**Official Transcript of Proceedings**  
**NUCLEAR REGULATORY COMMISSION**

Title:                   Advisory Committee on Reactor Safeguards  
                              Kairos Power Licensing Subcommittee  
                              Open Session

Date:                   Monday, October 17, 2022

During today's meeting, the Subcommittee will review the staff's Safety Evaluation on the Topical Report entitled "Fuel Qualification Methodology for the Kairos Power Fluoride Salt-Cooled High Temperature Reactor," Revision 2.

# Annular Fuel Pebble and TRISO Particle Design

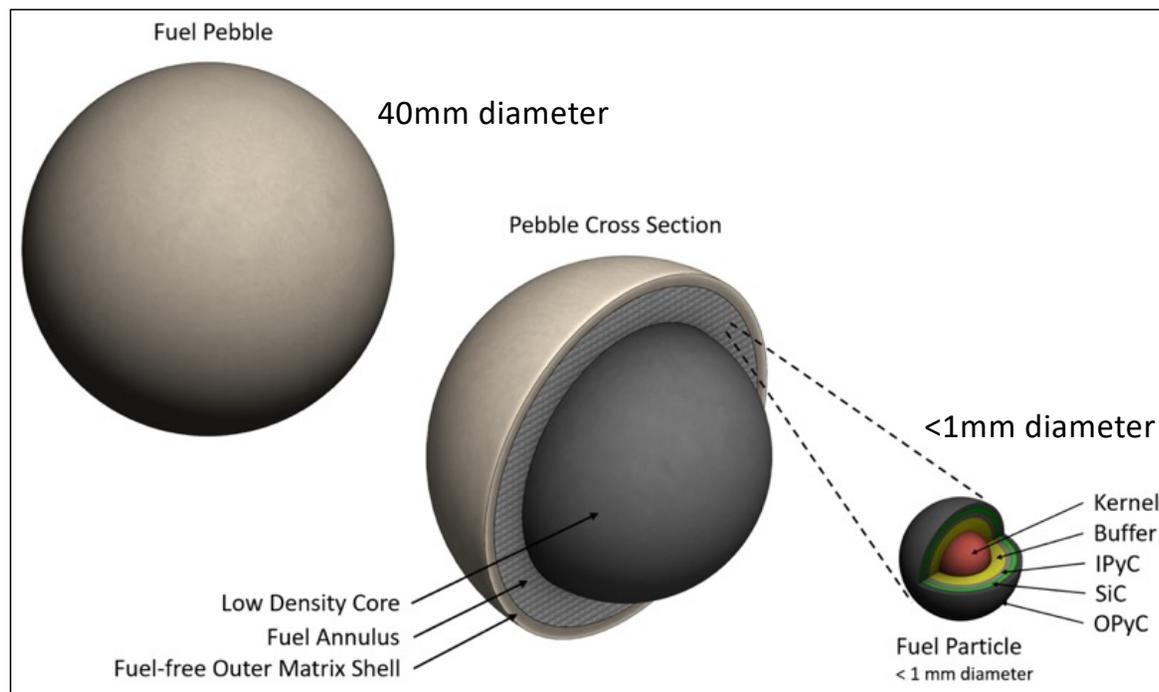
3 MEMBER REMPE: Can we go back to the prior  
4 slide, please?

5 You're right, we've seen this before. But  
6 this pebble and the way it's fueled is different than  
7 the German fuel because of this low density core  
8 region. But are there other differences? Are the  
9 pebbles packed more closely than the German fuel? And  
10 this fuel-free outer matrix shell, how does that  
11 differ from what we've seen in Germany or what's being  
12 done in China, for example?

5           At some point, I guess I'd be interested  
6           in how you feel comfortable that this tighter packing  
7           is not going to damage the coatings of the particle.

24          MEMBER REMPE: So, remind me what this  
25          overcoating is composed of? And do you have any

15 So, first off, the pebble is smaller in  
16 diameter. It's 40 millimeters versus 60 millimeters.  
17 We have this interior lower density core, and that's  
18 to allow the pebble to be net buoyant within the  
19 Flibe. That does not exist in the historic German  
20 pebble.

21 The fuel region contains a higher packing  
22 fraction of particles than historically have been done  
23 with German pebbles, but it's consistent with what has  
24 been done with compacts, and specifically, with AGR  
25 compacts.

1           The fuel-free outer shell is thinner in  
2           dimension than has historically been used in the  
3           German pebbles.

8           MR. LATTA: Sure. So, in the  
9           manufacturing/development program we have, we'll be  
10          fabricating these with surrogate materials and proving  
11          through deconsolidation-leach-burn-leach after  
12          fabrication that the defect fraction of particles  
13          post-fabrication are within the specifications. So,  
14          we'll be able to demonstrate through sampling of  
15          product that we meet our specification.

16          MR. TOMKINS: And the particles are  
17          overcoated. So, they have a built-in, you know,  
18          separation, if you will.

19          MR. LATTA: Yes. So, all particles are  
20          overcoated, and then, poured into these molds to  
21          fabricate and press this region. And so, there's  
22          specifications on that as well to ensure that those  
23          things are met.
